City Of Biloxi Building Code Plan Review  
Biloxi Building Code Office  
676 Dr. Martin Luther King Blvd.  
Biloxi, MS.  
Attn: Michael Hornbeck

Ref: La Quinta Inn Suites  
Cedar Lake Road  
Biloxi, MS.

LA QUINTA INN & SUITES  
CEDAR LAKE RD.  
SPRINKLER/FIRE ALARM  
JOB #: 07022

DATE: July 6, 2007  
TO: To Whom It May Concern  
FROM: City of Biloxi, Fire Department  
RE: Plan Review Comments

## F-C-2286

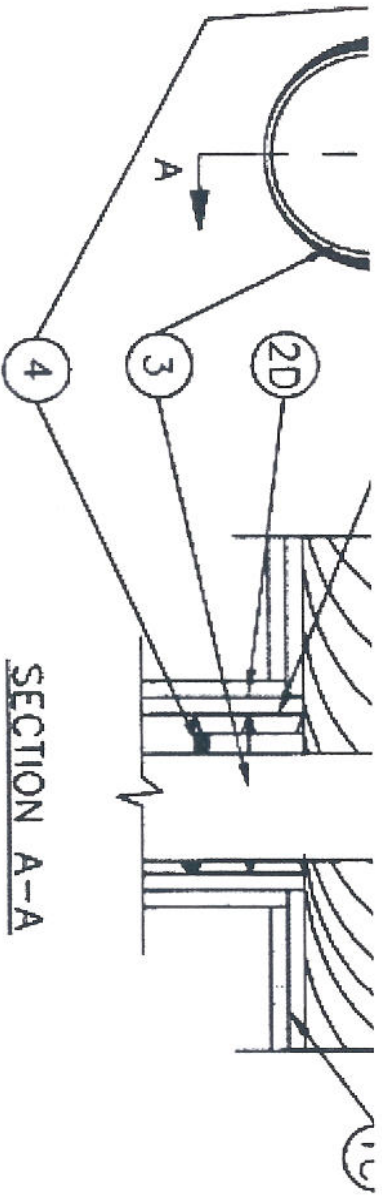
The enclosure behind the toilets shall be capped off in the attic using two layers of 5/8" type "X" sheet rock. The enclosure behind the bathtubs shall be enclosed from the top using three layers of 5/8" type "X". Per detail LL sheet a-7. All piping penetrating a rated assembly shall be fire caulked using the appropriate type of fire caulking for that penetration. All penetrations shall be fire caulked using Grabber IFC and is approved for 4" PVC pipe, with a point of contact from 0 in. to 3/4 in. All arches in the units shall have 5/8" type "X" sheet installed on it to complete the fire rating assembly for that area.
